19 April 2023
30552.9082

Response to s92 requests - Point Erin Tunnel

Further to your letter dated 28 March 2023 requesting further information with respect to application BUN60415108, we provide the below response.

POINT ERIN - CENTRAL INTERCEPTOR (DSCIN)
82 GRAVITY SEWER INCLUDING MANHOLES
POINT ERIN SITE - OPERATIONAL PHASE PLAN - VEHICLE ACCESS LAYOUT

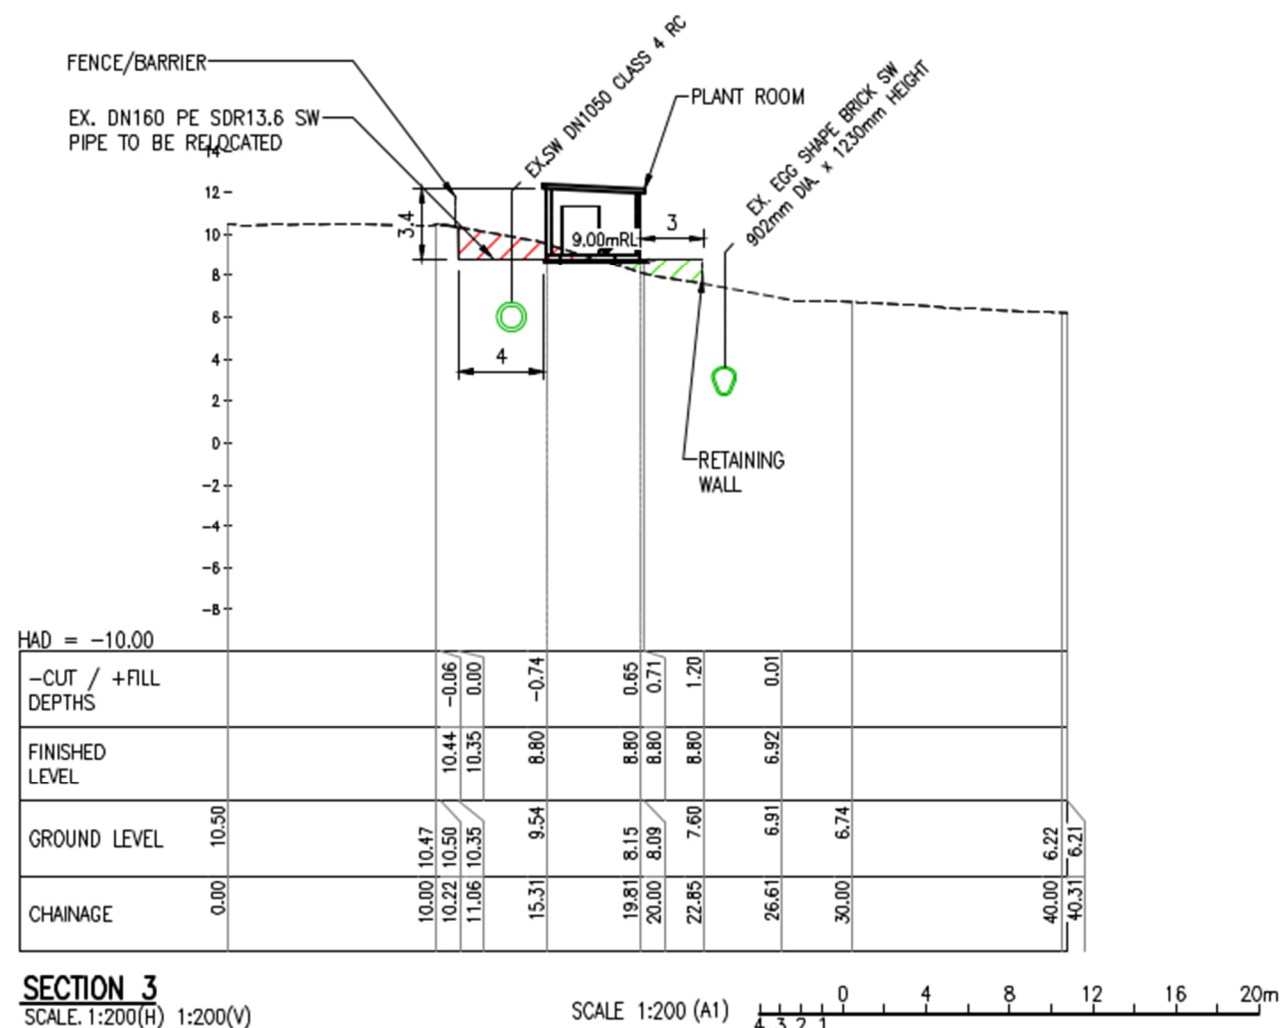
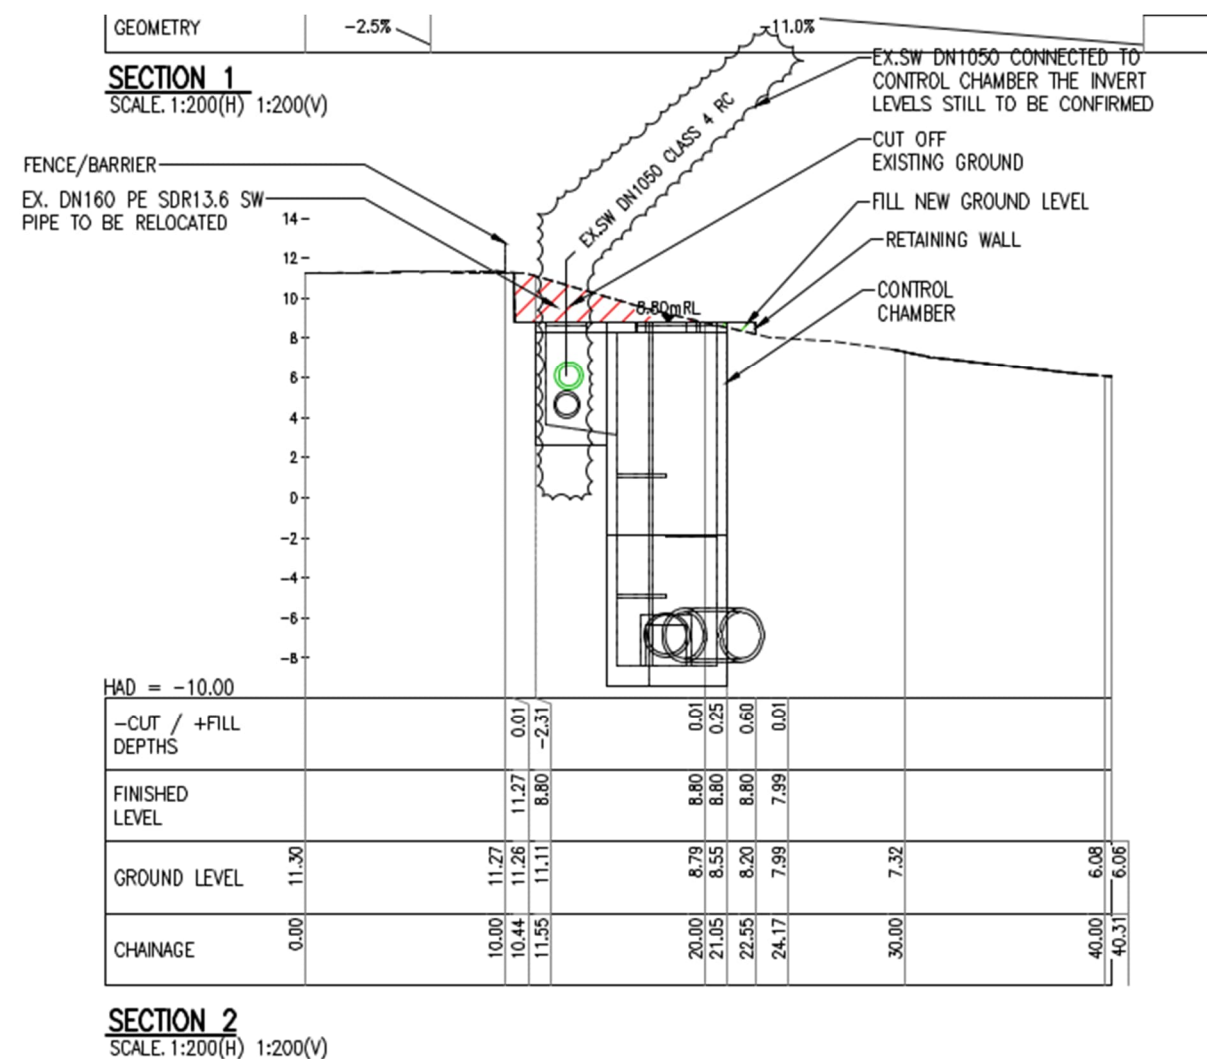
- 27 *Please demonstrate that within the 10m wide permanent platform accommodating the plant room and chamber covers (i.e., post construction) that there will be sufficient space directly along the retaining walls, or in close proximity, to enable planting. The submitted plan shows a generic area but does not specify if this is required to be paved (e.g., for access purposes) or is suitable for planting. This is requested as the proposal relies on the integration of the wall to manage long term adverse effects, but limited information has been provided to demonstrate that this is achievable.*

Please refer to the marked up planting plan (Appendix B) showing areas which are available for planting. The final location and type of planting will be determined through the design process in consultation with Auckland Council and mana whenua. The indicative planting plan demonstrates

that it is possible to plant in proximity to the retaining walls, which provides one potential method for visually integrating the wall(s) with the surrounding landscape.

Cross sections showing permanent retaining wall to west and options for retaining or embankment on the eastern side of the plant room platform.

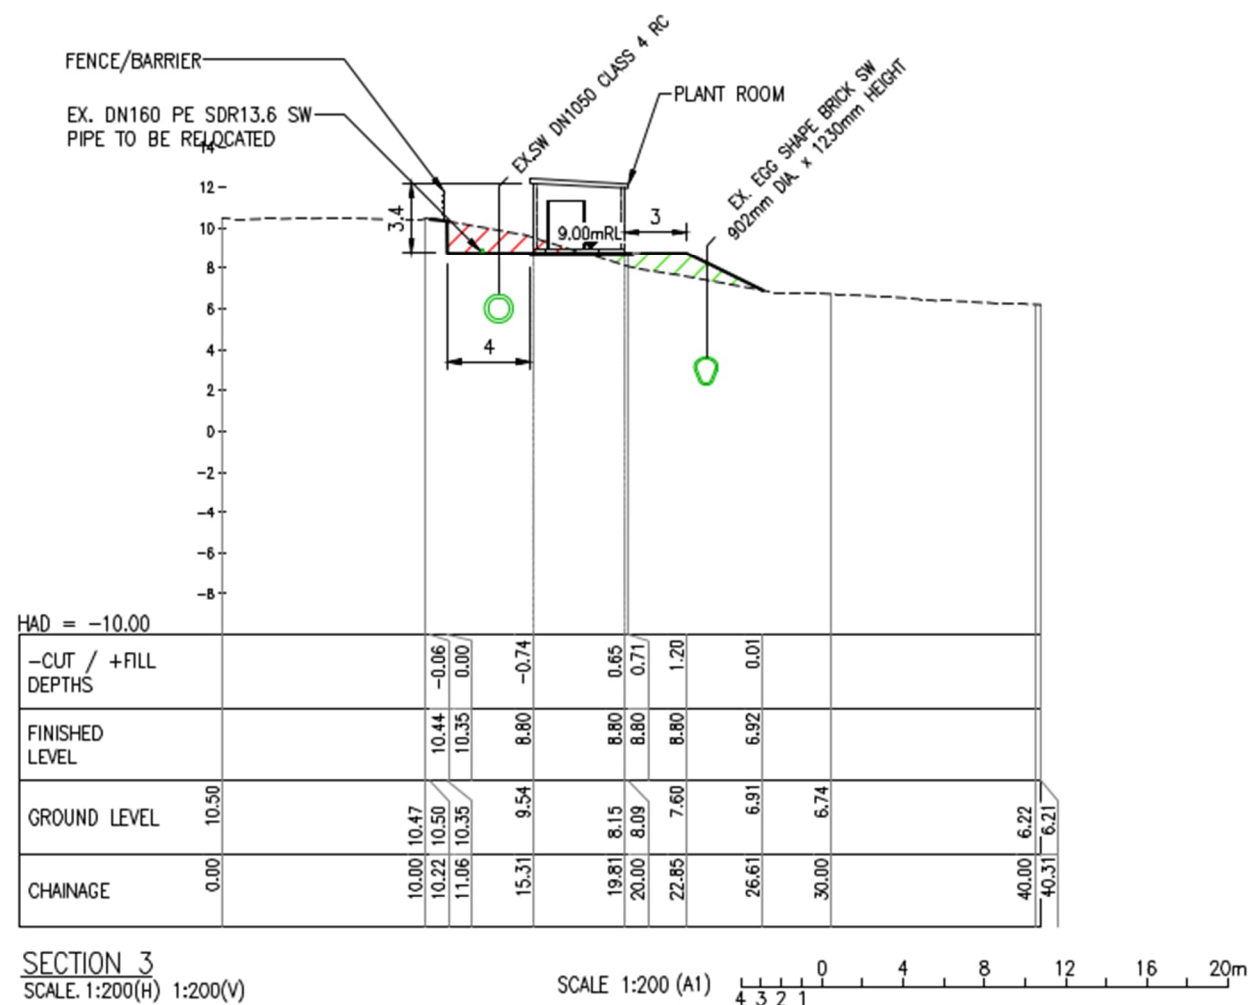
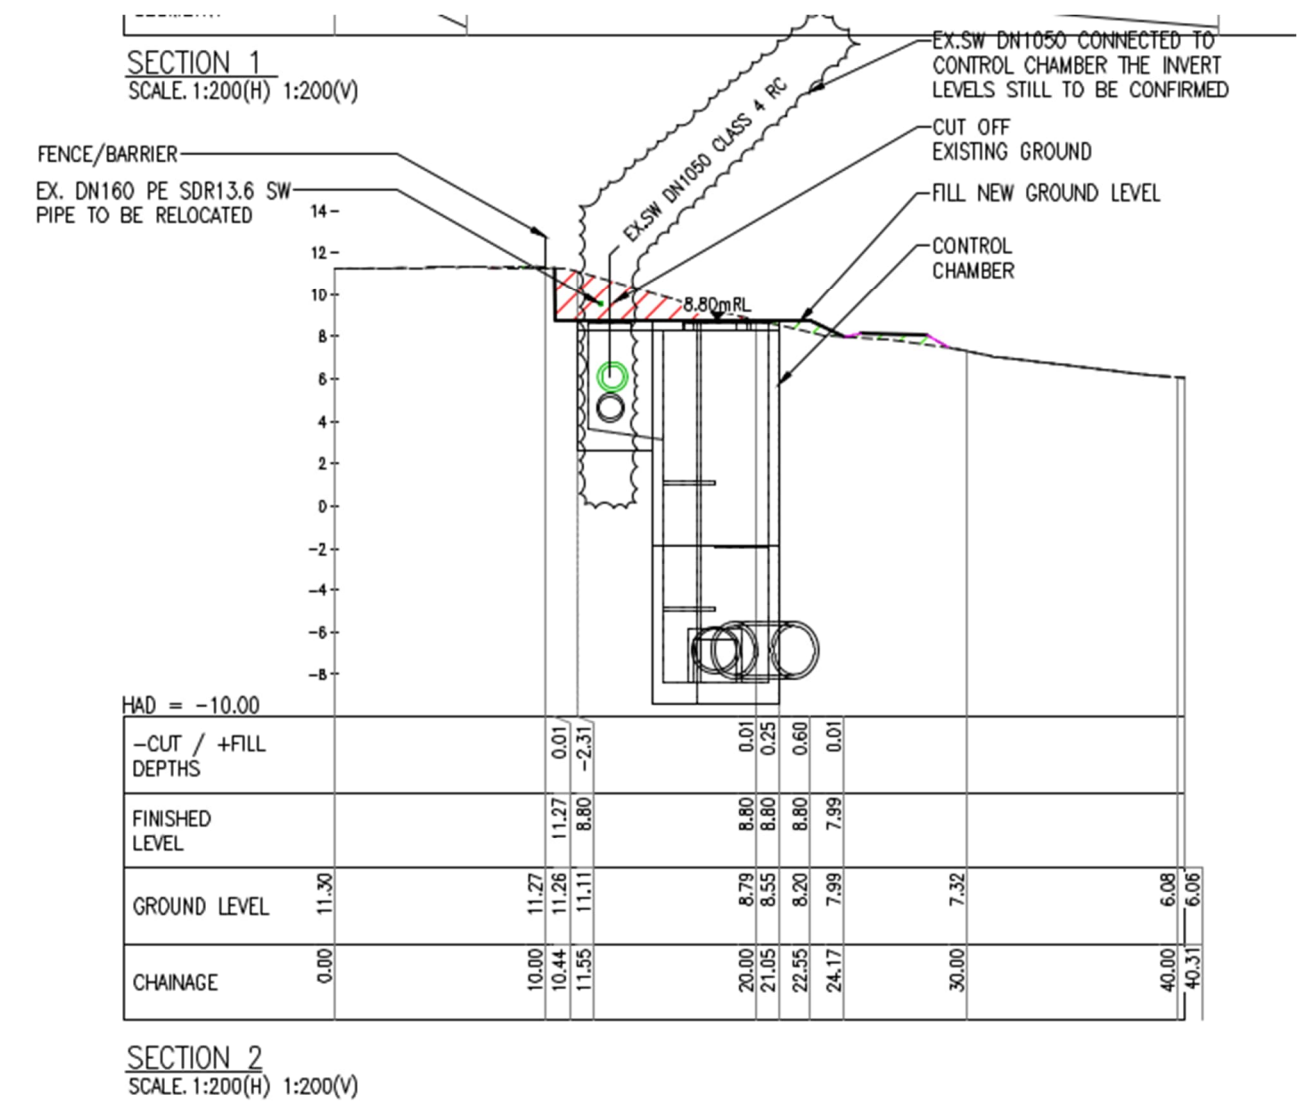
- 26 *The AEE notes (page 45) the permanent area within the southwest of the site will reduce to 10m in width, with a permanent retaining wall along Curran Street and a smaller permanent retaining wall (or reinforced embankment) along the eastern edge. The section provided in the drawing set only shows the reinforced embankment option. Accordingly, please provide an additional section showing the retaining wall option in order to allow for an understanding of both potential outcomes to be obtained*

Please refer to Appendix B which provides sections through the south-west corner of Point Erin Park. These show the reinforced embankment option, and the retaining wall option along the eastern edge of the plant room platform. Which option is selected will be determined through the design consultation process. The options present different opportunities for visual integration – the embankment could be planted, whereas the retaining wall would provide a 'layering' of structures and could also have seating built into it, serving a dual purpose.

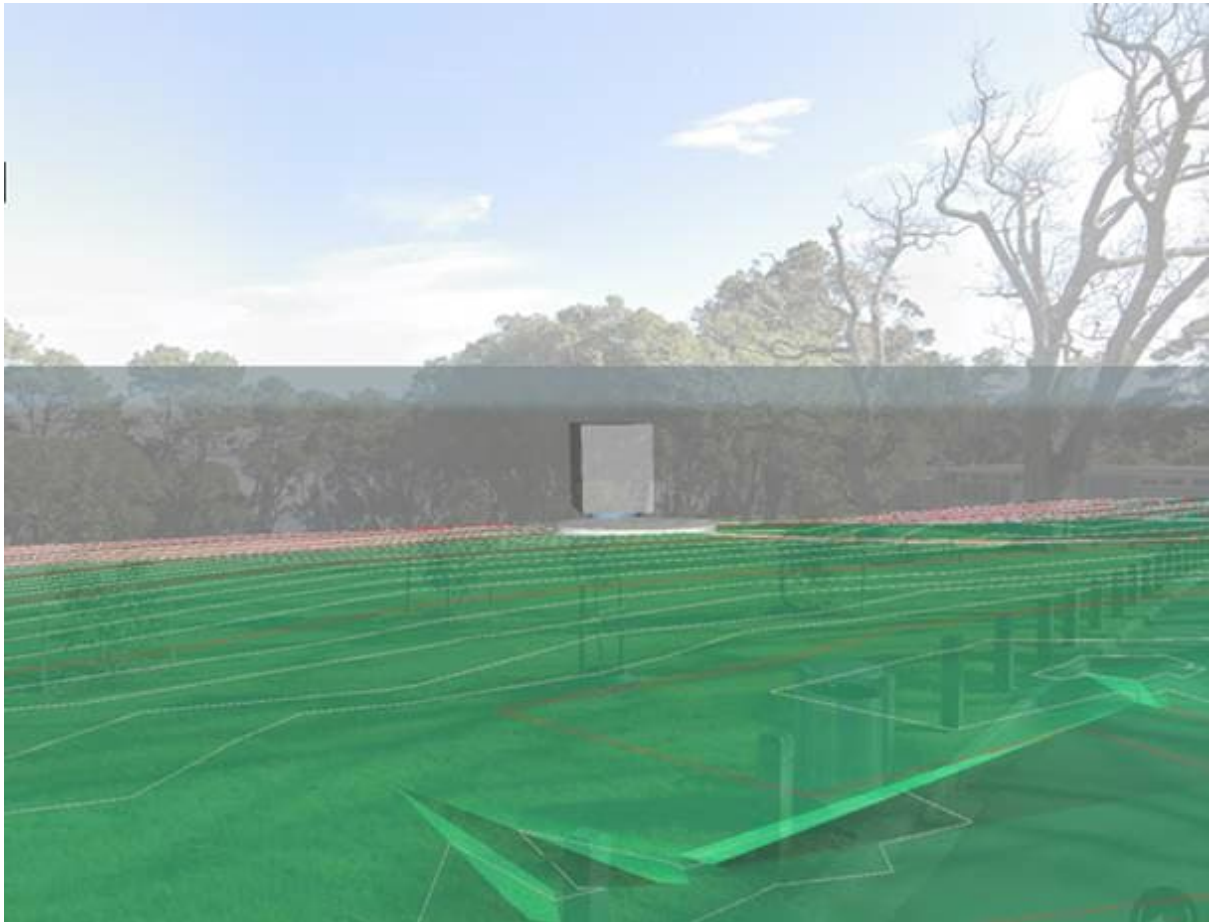
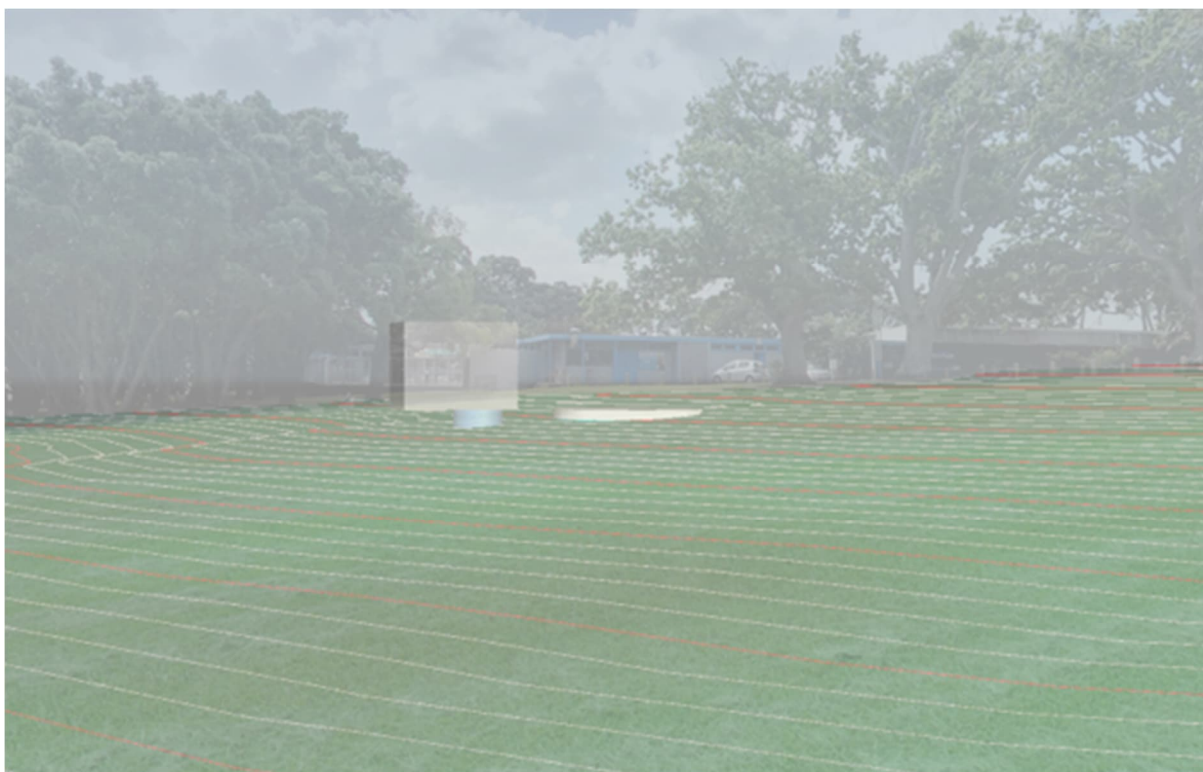
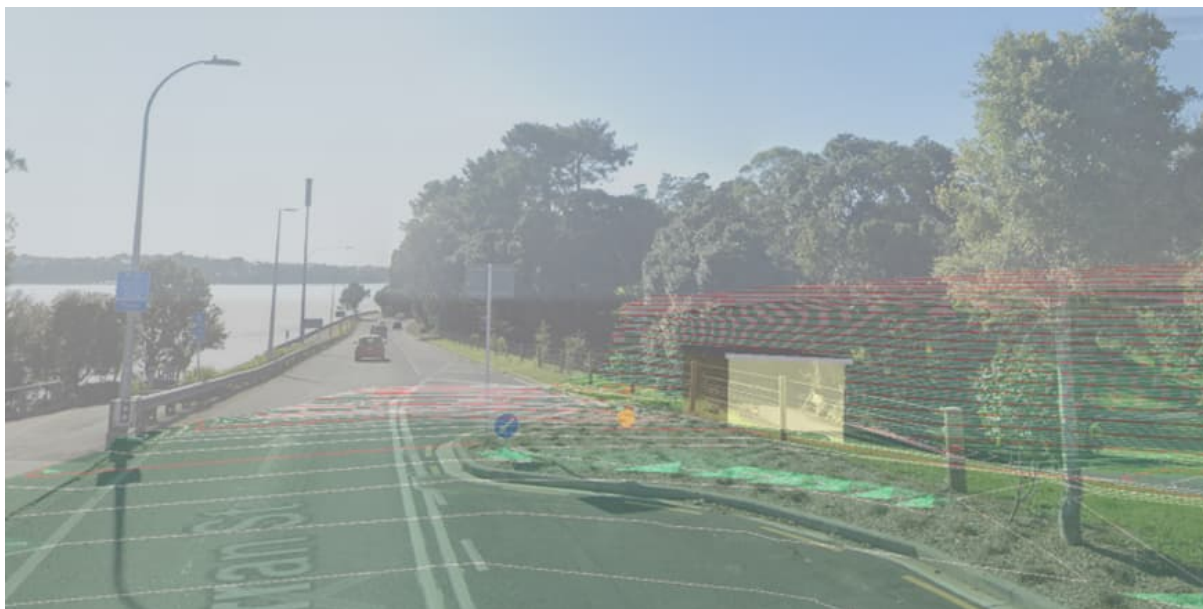
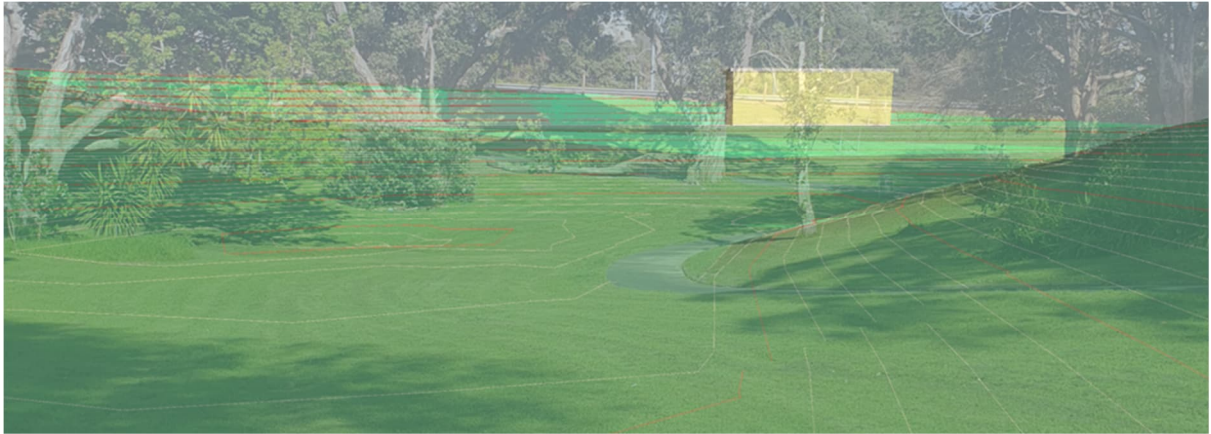
- 23 *The permanent above ground structures and buildings required include venting (2.6m² vent and 10m² total area and approximately 3m high), a plant room (40m² in area and 4m high) and retaining walls. No design details have been provided for these permanent structures, as they are to be undertaken later through consultation with Council and mana whenua etc., which has been offered as a condition of consent. However, to understand potential adverse effects associated with their visual presence, a general idea of the location, relationship, and scale of these structures and buildings within the site is required. Accordingly, please provide perspectives or model views of the site illustrating the proposed location and scale of the: vent within the terminal shaft location; and the plant room and retaining walls (or retained embankment) within the control chamber location, as seen from within the site and from the immediately surrounding catchment.*

To provide further clarity on the potential landscape and visual effects of the project, the following additional information has been compiled in Appendix B:

- Memo titled “Further information on potential design and appearance of above-ground infrastructure – Point Erin Park”, prepared by Tonkin & Taylor Ltd, dated 17 March 2023.
- A ‘mood board’ showing examples of design precedents which will be used to commence discussions on options for the design consultation process with mana whenua and Auckland Council.
- Images showing the 3-D design model for the project overlain on photographs of the site to provide a rough indication of the general bulk and location of above-ground infrastructure, noting that these do not include any planting or potential design elements to integrate them with the surrounding environment.
- An indicative planting plan, showing potential areas of planting.
